LAKE PONTCHARTRAIN, L.A.  
AND VICINITY  
**LAKE PONTCHARTRAIN  
HIGH LEVEL PLAN**

**DESIGN MEMORANDUM NO. 20  
GENERAL DESIGN**

**ORLEANS PARISH  
JEFFERSON PARISH  
17th. St. Outfall Canal  
(Metairie Relief)**

CELMV-ED-PG (CELMN-ED-SP/15 May 90) (1105-2-10c) 3d End  
Mr. Eckenrod/ts/5925  
SUBJECT: Lake Pontchartrain, Louisiana and Vicinity, High Level Plan, Design  
Memorandum No. 20 - General Design, 17th Street Outfall Canal

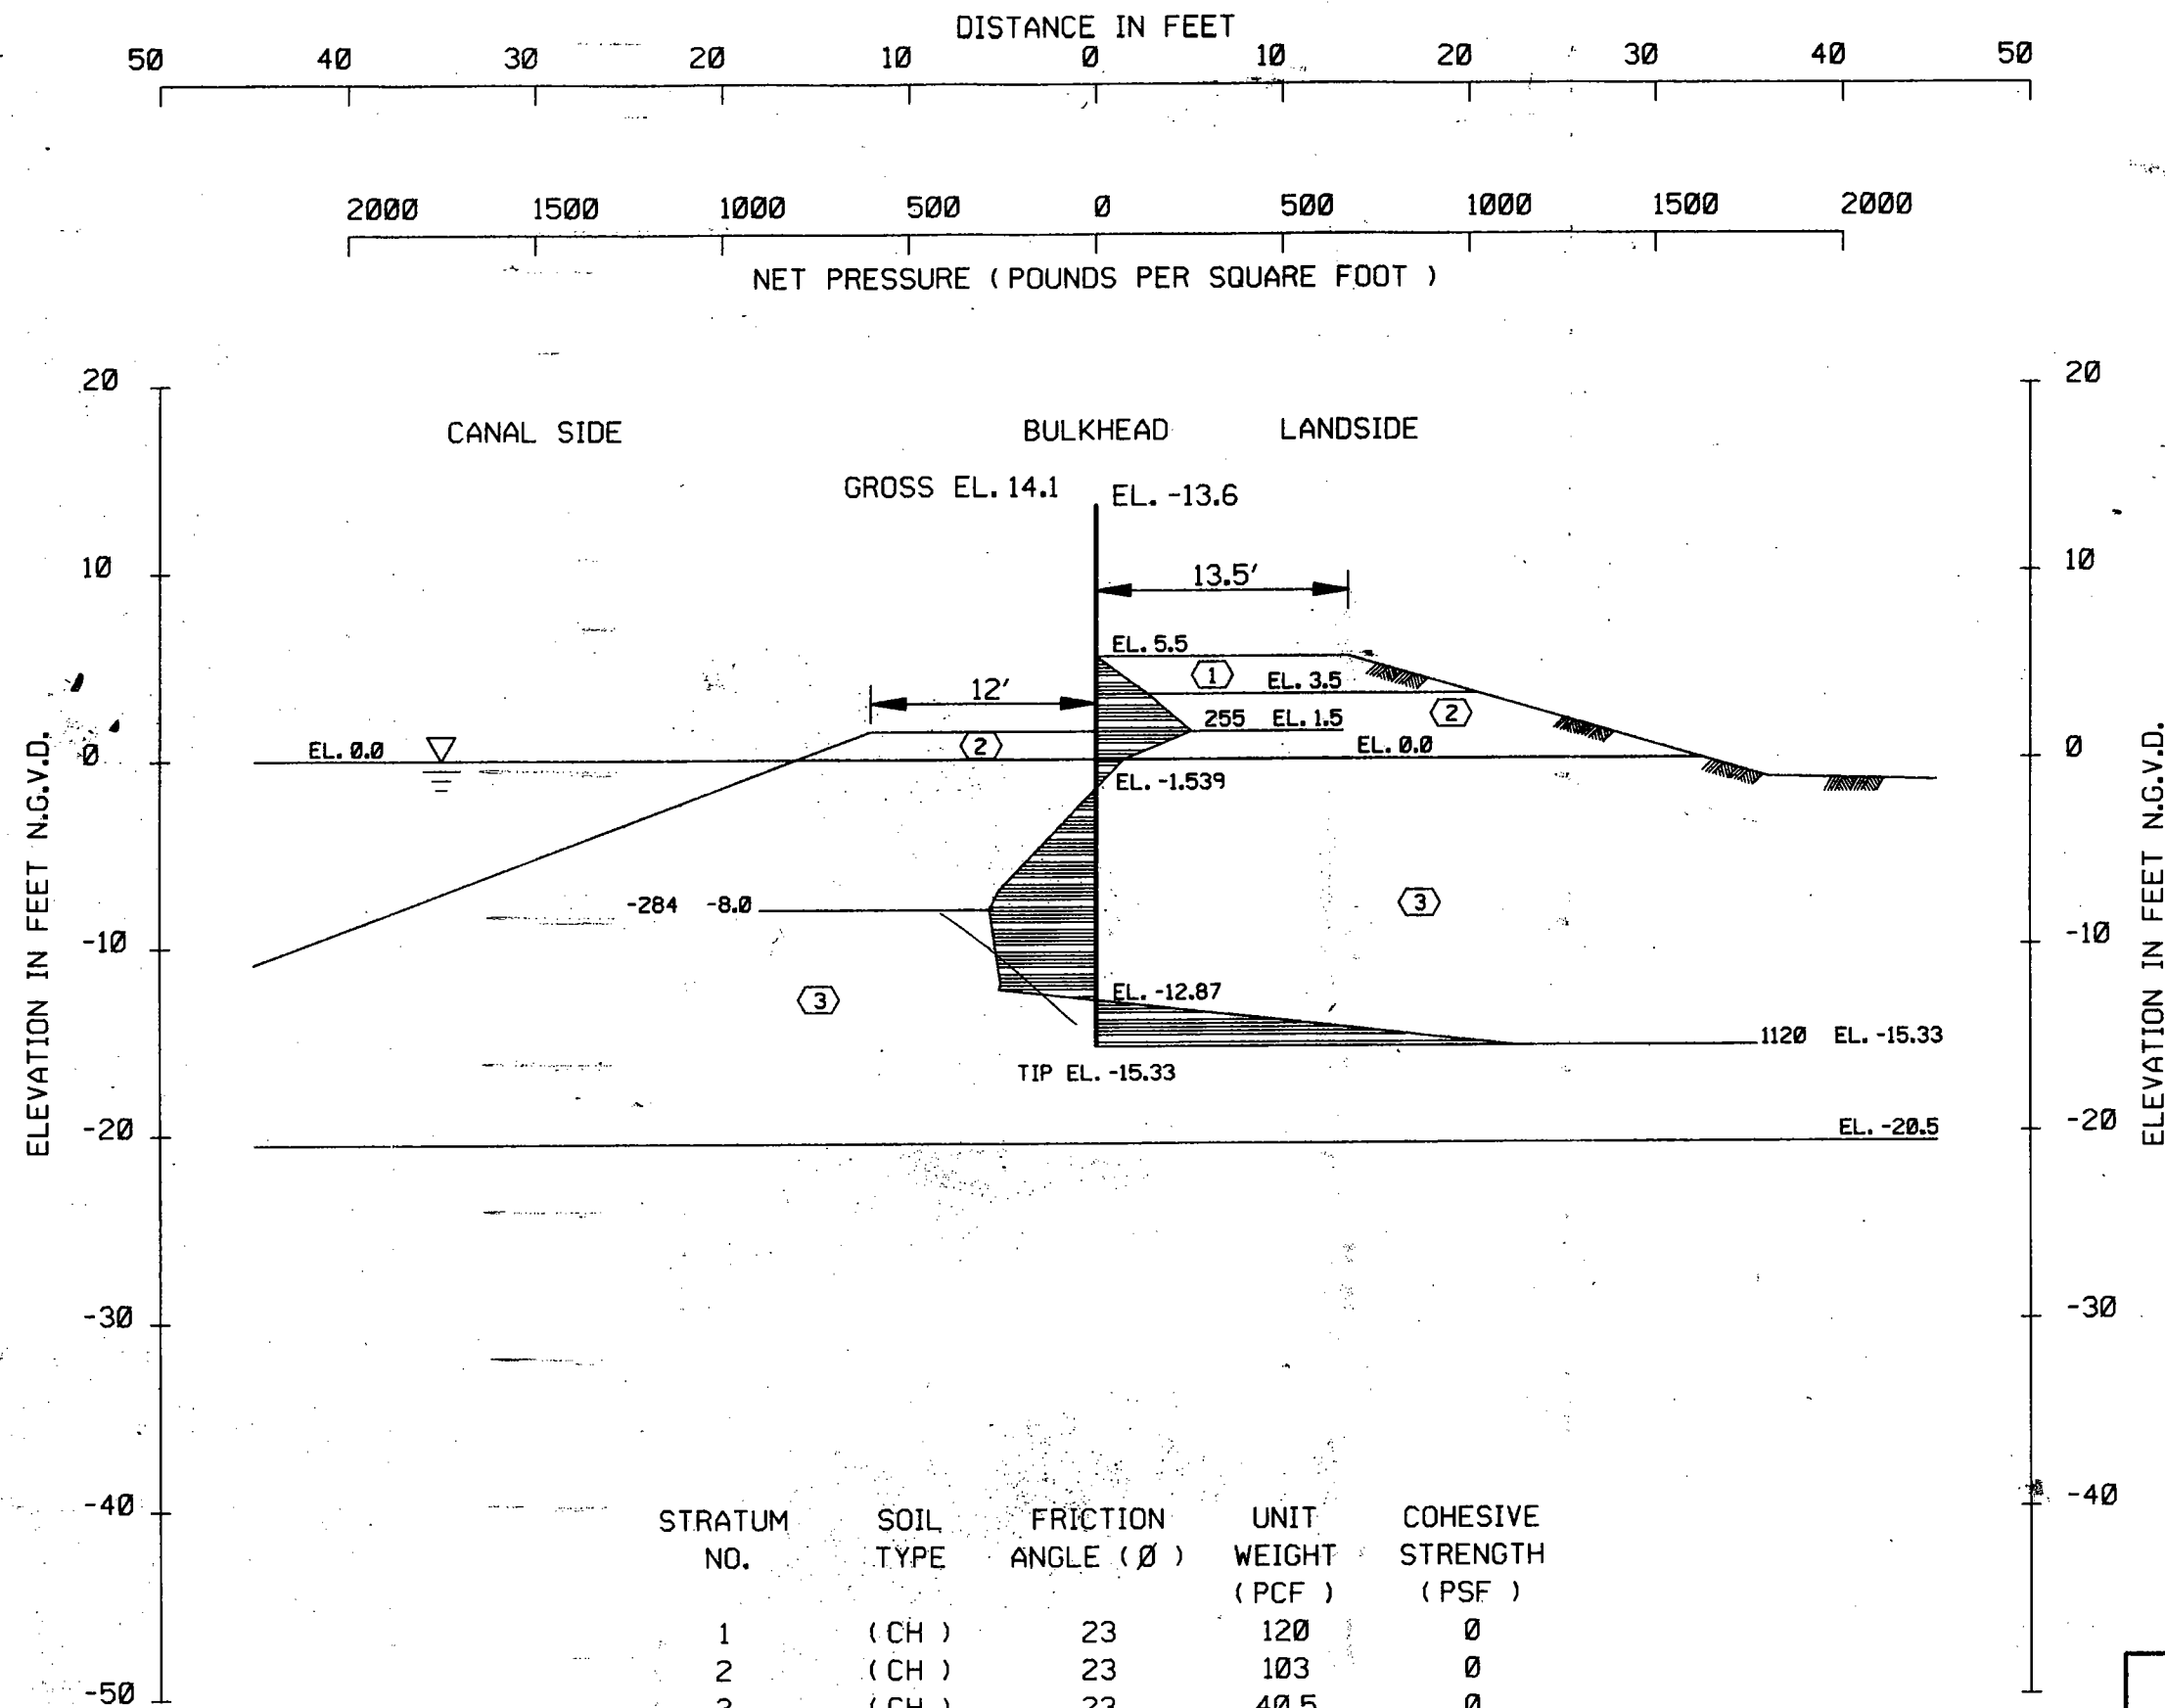
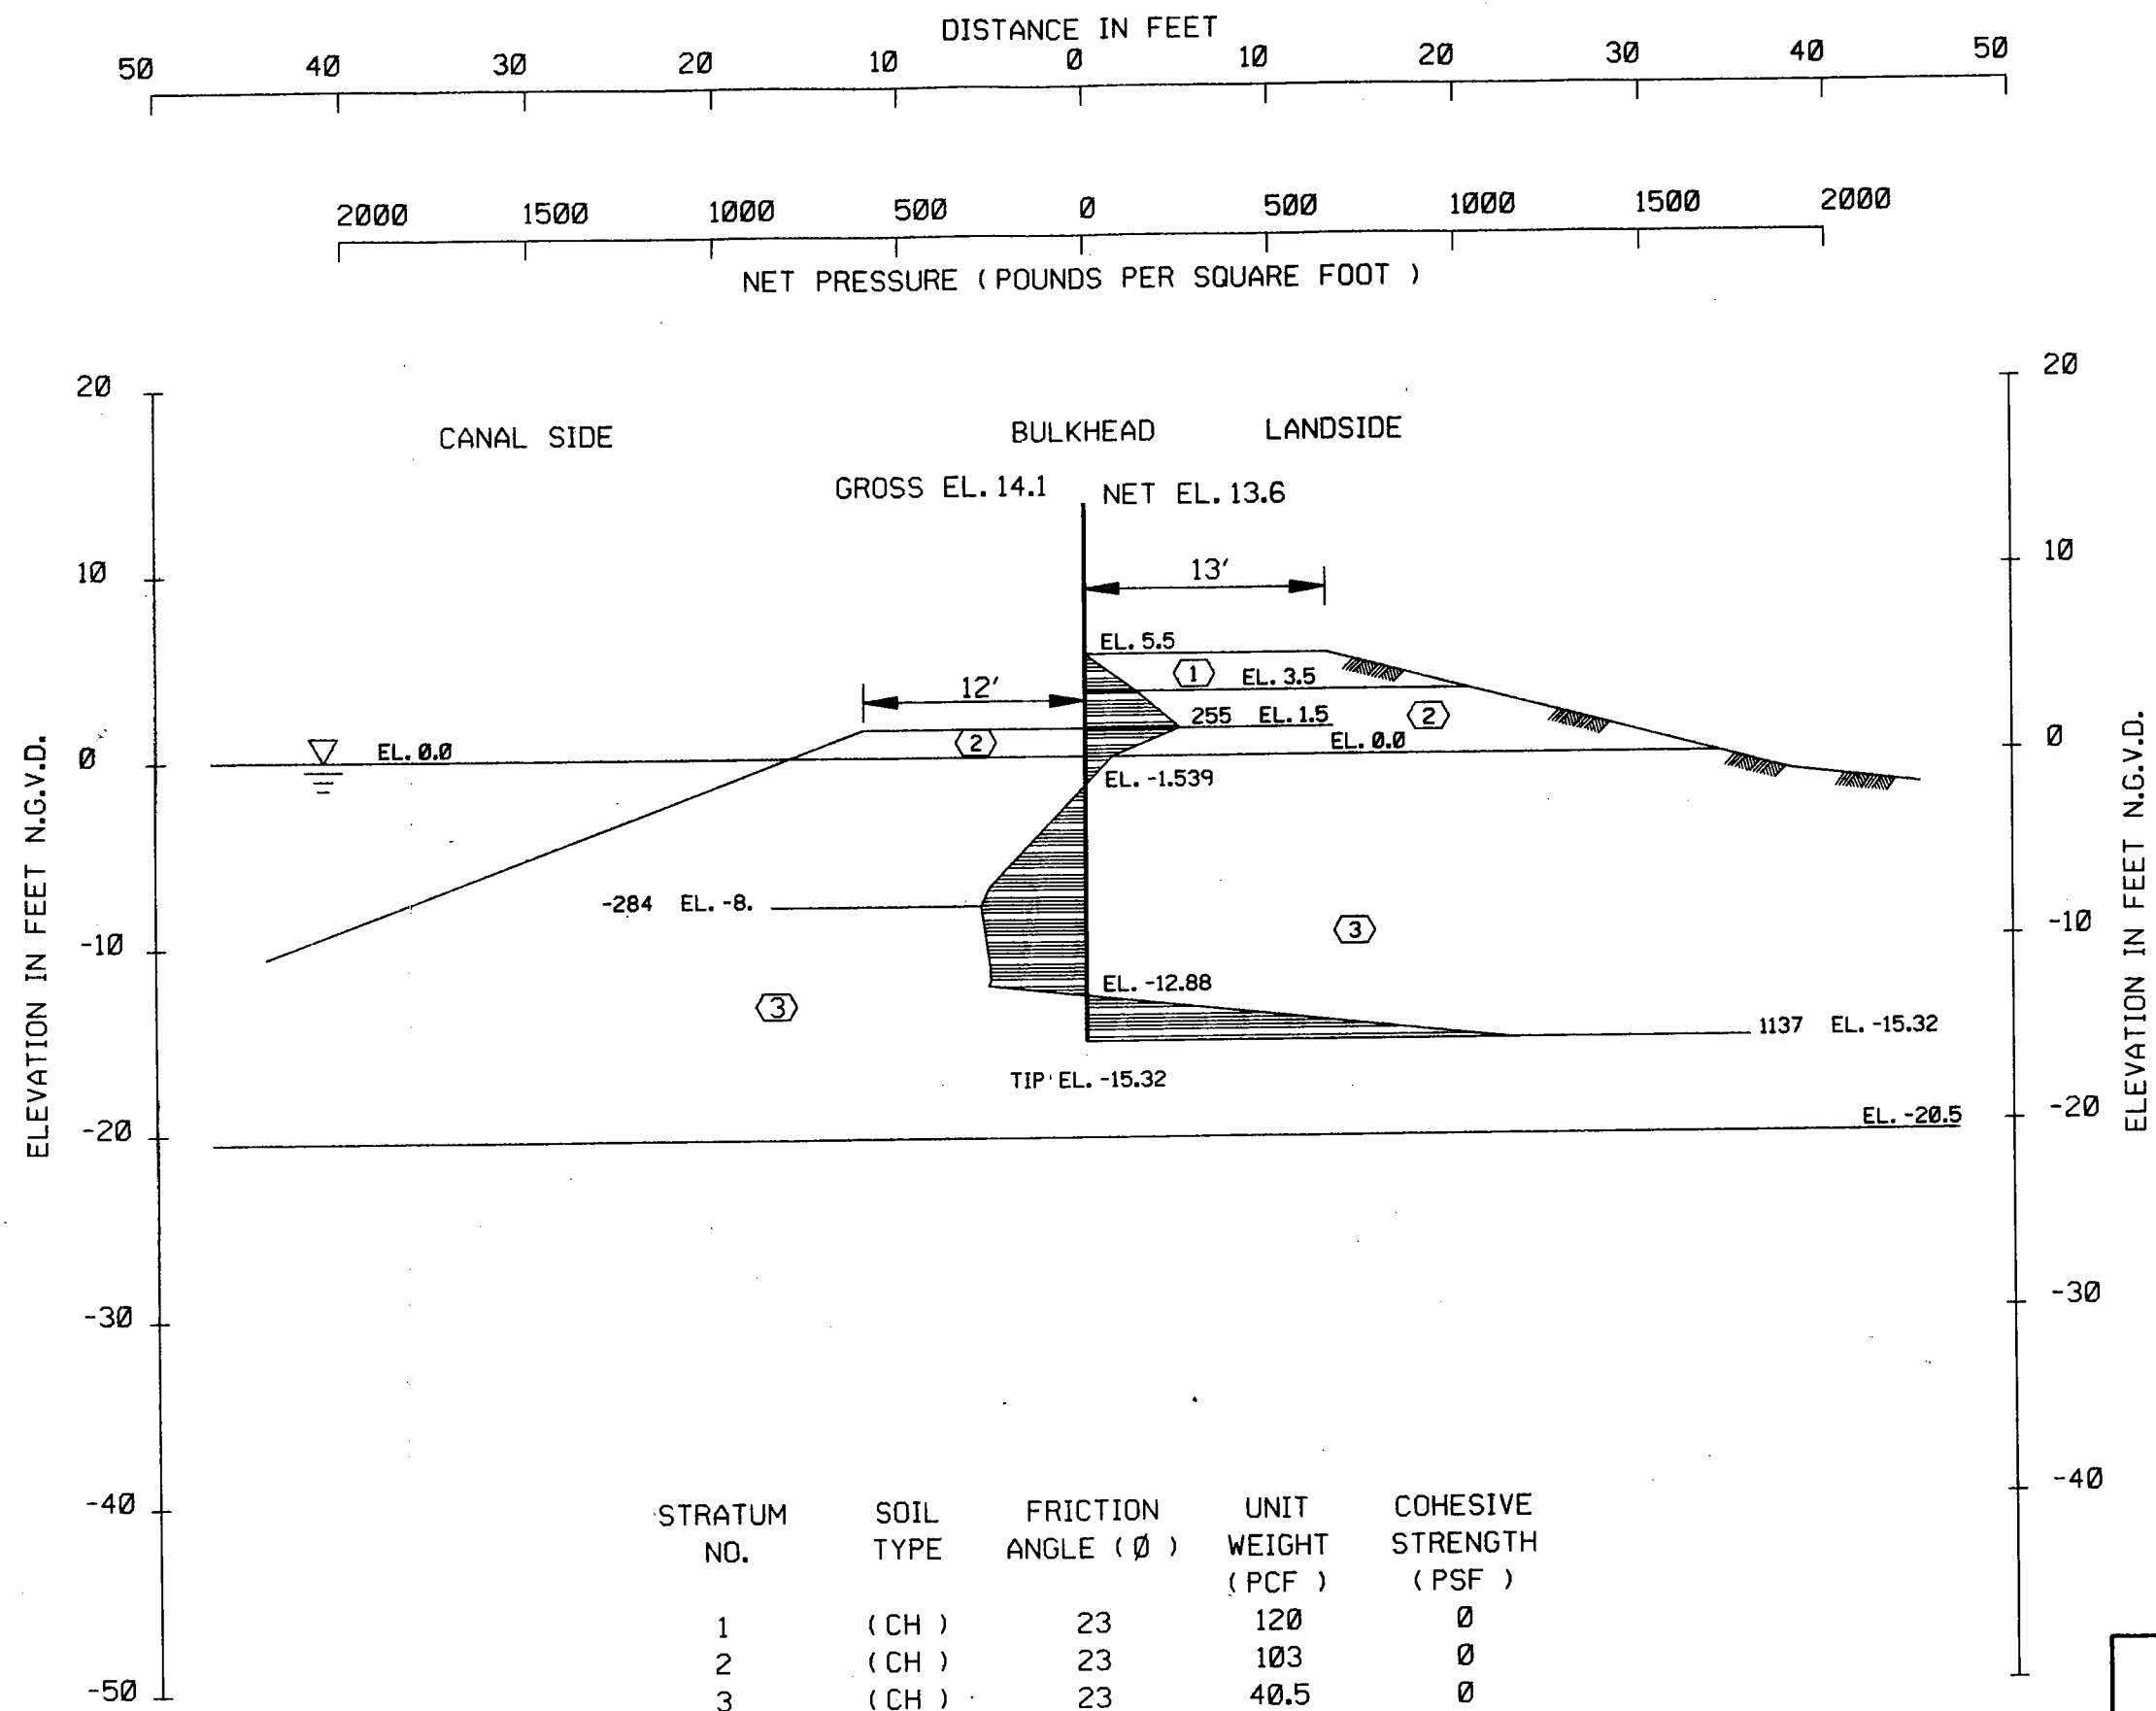
d. Para 29c. Also refer to the tied back and braced wall analyses on Plates 121-124. These analyses are based on the "Q" case soil strengths, a canal level at el -5.0, and a factor of safety of 1.5. Since these sheet pile bulkheads permanently retain soil, they should also be analyzed using "S" soil strengths, a factor of safety of 1.5, and at the normal canal level of el 0.0.

m. Plates 121 through 124. The walls shown on these plates should be evaluated for the anchor forces and resulting stresses on the anchors and the sheet piling should be checked using the conditions shown except change the water level on the canal side to el 0.0 NGVD and use soil properties for the 'S' case and a F.S. = 1.5.

d. Comment d. Para. 29c. The analyses presented were for the Q-CASE soil strengths, a canal level at EL. -5.0 and a factor of safety of 1.5. For plates 121, 122, and 124 the actual design (completed before Dec 87) was controlled by the S-CASE, F.S. = 1.5, and canal level at EL -5.0. The design on plate 123 (completed after Dec 87) was based on the S-CASE F.S. = 1.2 with canal level at EL -5.0; S-CASE F.S. = 1.5 with canal level at EL 0.0; or the 3:1 penetration to head ratio. All the braced walls and tieback walls have been constructed. The tip penetrations shown on plates 122-124 are deeper than the minimum required tip penetration (Encl 3). Intermediate tip penetrations were used to reduce the anchor forces.

m. Comment m. Plates 121 through 124. Concur. Revised plates 121 through 124 are enclosed as Encl 3.
